Application for Disposal Works Construction Permit

RE: Septic System Repair & Local Upgrade Approval
Kohler Residence, 278 Middle St., Amherst, Ma.

To: Amherst Board of Members
From: David Zarozinski, Sanitarian *DZ*
Re: Local upgrade approval from Title V

**MARY E. KOHLER 278 MIDDLE ST.,
AMHERST, MA.**

PLOT PLAN

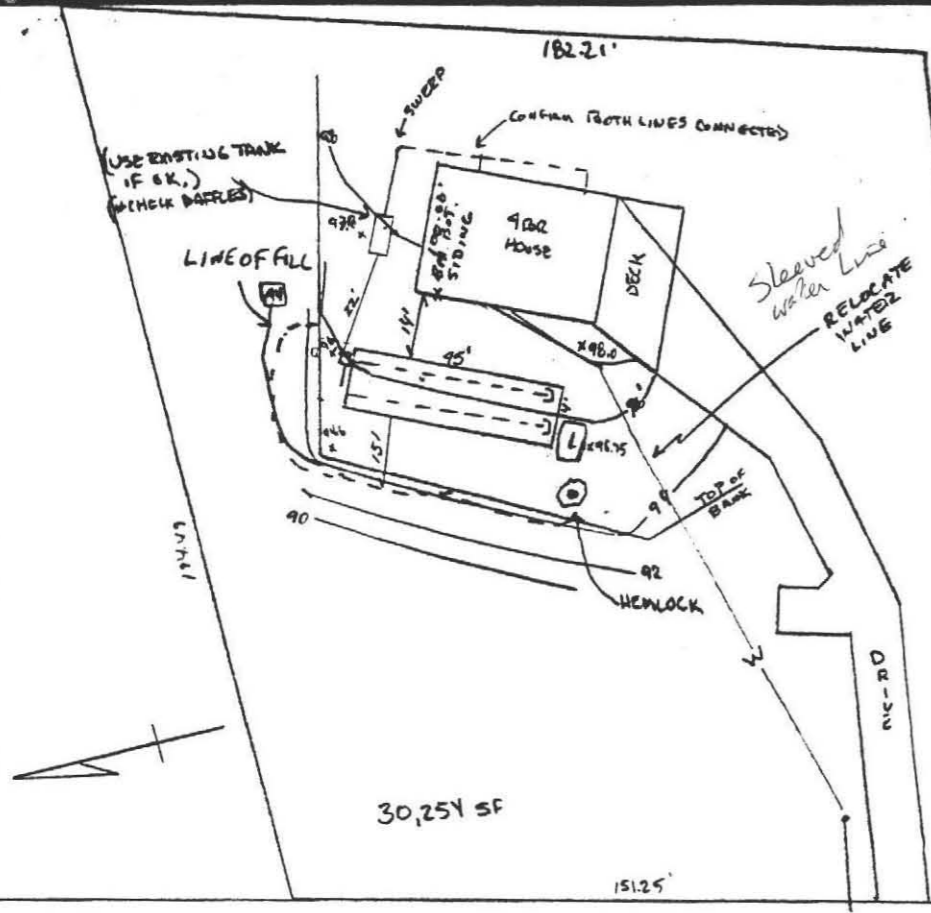
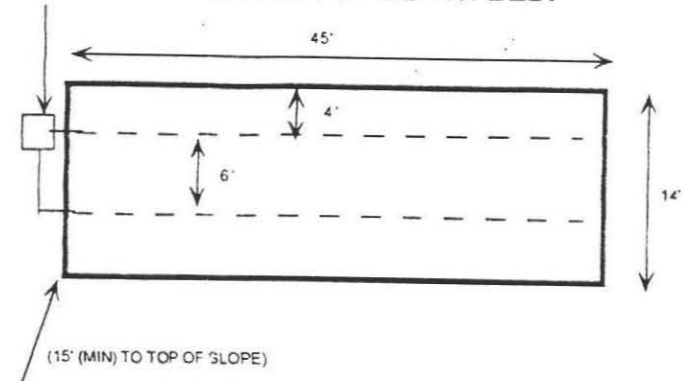
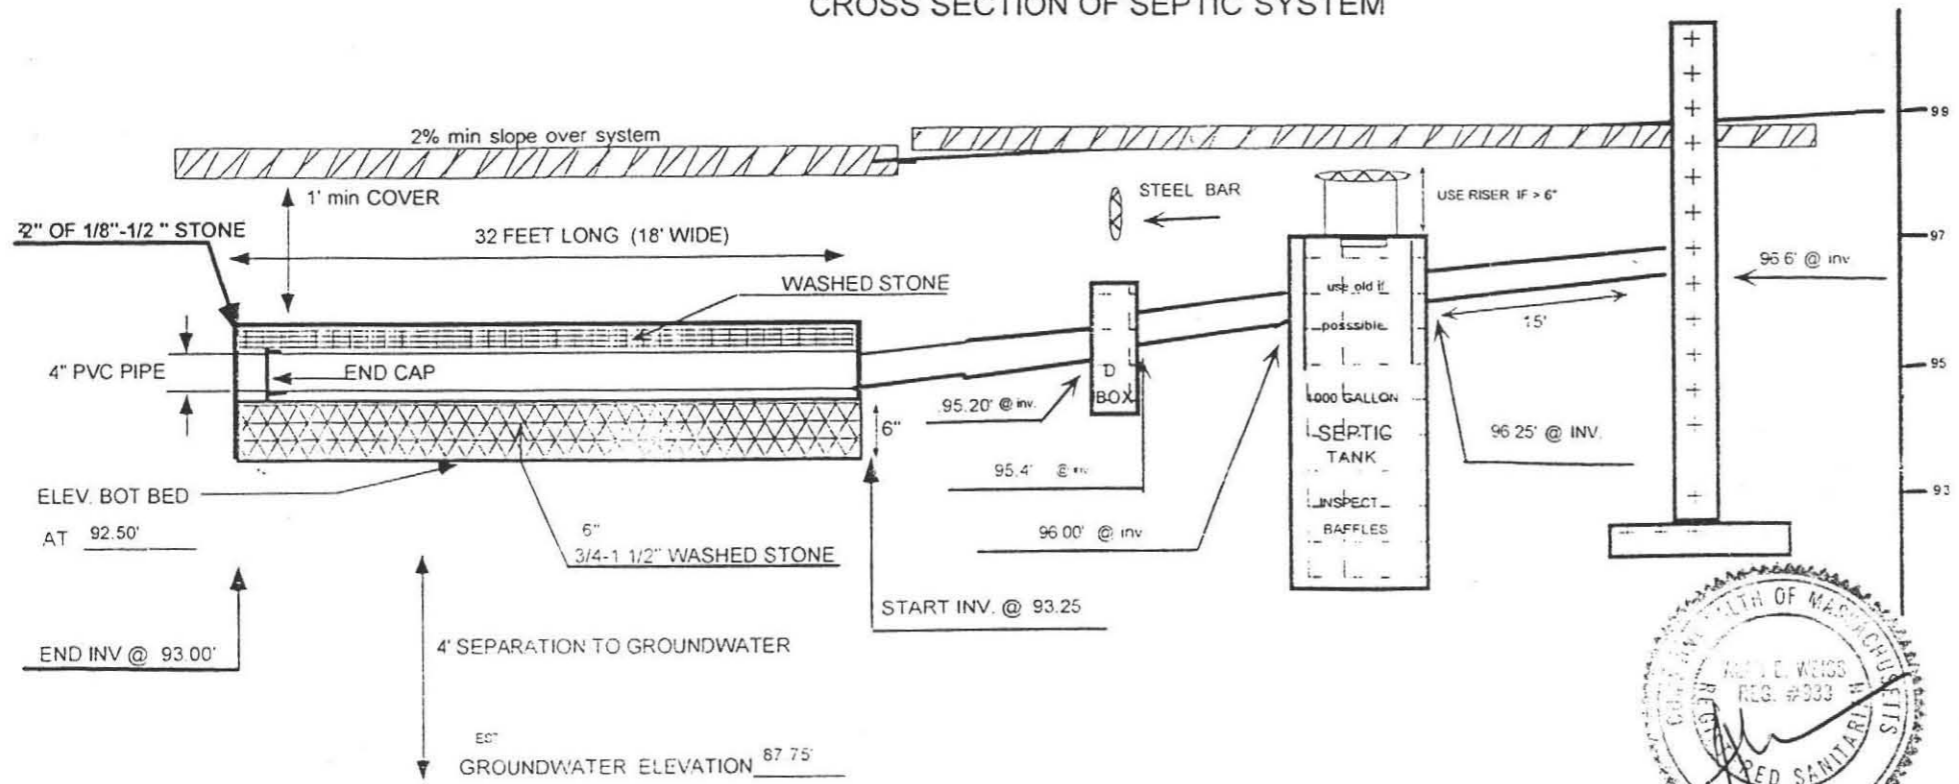
A Local Upgrade Approval from Title V (310 CMR 15.211) is requested for the repair of the system at the above mentioned property. The following variance is noted:

- lack of space for 20' foundation setback due to nearby slopes and house proximity. The provided setback is 14' versus the conforming 20'.
- In addition, a variance to the Town's 25% overdesign requirement is requested to be provided.

1. Local upgrade approval from Title V (310 CMR 15.211). Lack of space for twenty feet (20') foundation setback due to slopes and house proximity.
2. Variance request to The Town's 25% overdesign (copy enclosed).

I would grant these variance requests for the following reasons:

1. The new system will be installed downhill from the foundation wall and with the other slopes and spatial constraints this plan makes the best land use of the area.
2. Town water is available.
3. The addition of the Town's Regulation of 25% larger would do unjust manifestation to the home owner. This plan does meet today's Title V requirements.
